File: pocket_casino.kicad_sch

Title: Pocket Casino

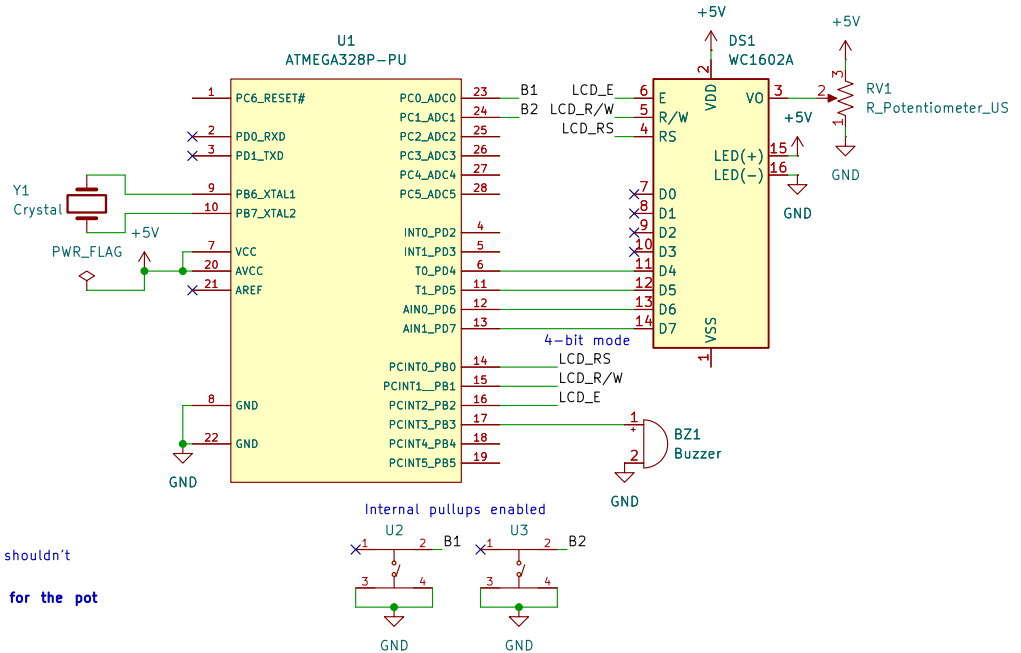
The designator for the push button shouldn't be UX

Double check footprints. Especially for the pot
